SERVICE BULLETIN

BULLETIN NUMBER: SB-0018
REVISION: 02
DATE: JULY 2020 – Revised

PRODUCT DESCRIPTION: Paging Modulator Card

CODAN REFERENCE / ECO: ECO 6027

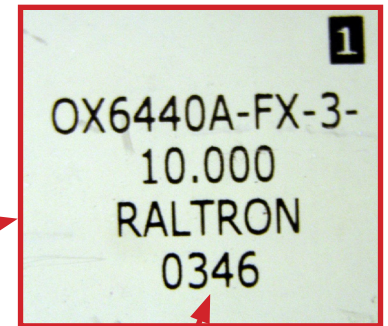
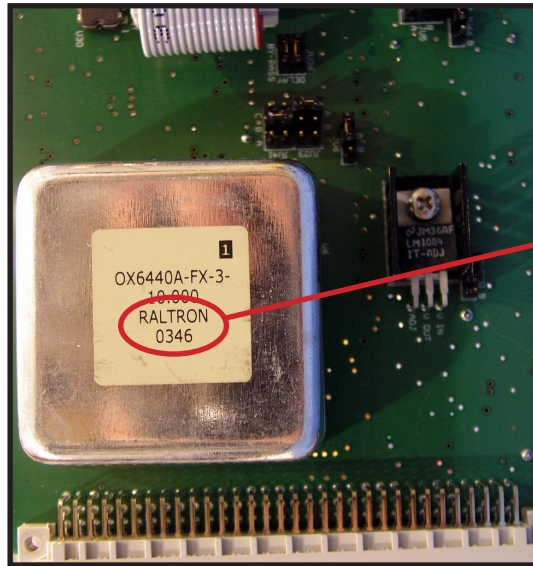
PRODUCTS AFFECTED:	Model Number:	Board Version:
	CI-PM-3-00	Affects all versions with Raltron OXCO modules with date codes less than 0610.

SYMPTOMS: Component failure could result in module failure or system failure.

CAUSE : Flux and solvent contamination inside the Raltron 10Mhz OXCO may cause a short which would lead the 9.5V regulator to fail, which may lead to excessive heating and burning of the circuit board.

Problem applies to all RALTRON OXCOs with date codes less than 0610

1. Contact Codan to arrange for a new replacement OXCO and rework instructions.
2. Contact Codan for return authorization for warranty repair or replacement.

Qty	UOM	Description	Part Number
1	EA	FUSE/SM, 500mA	5606-E1206500
1	EA	OCXO Module	2646-10000D12
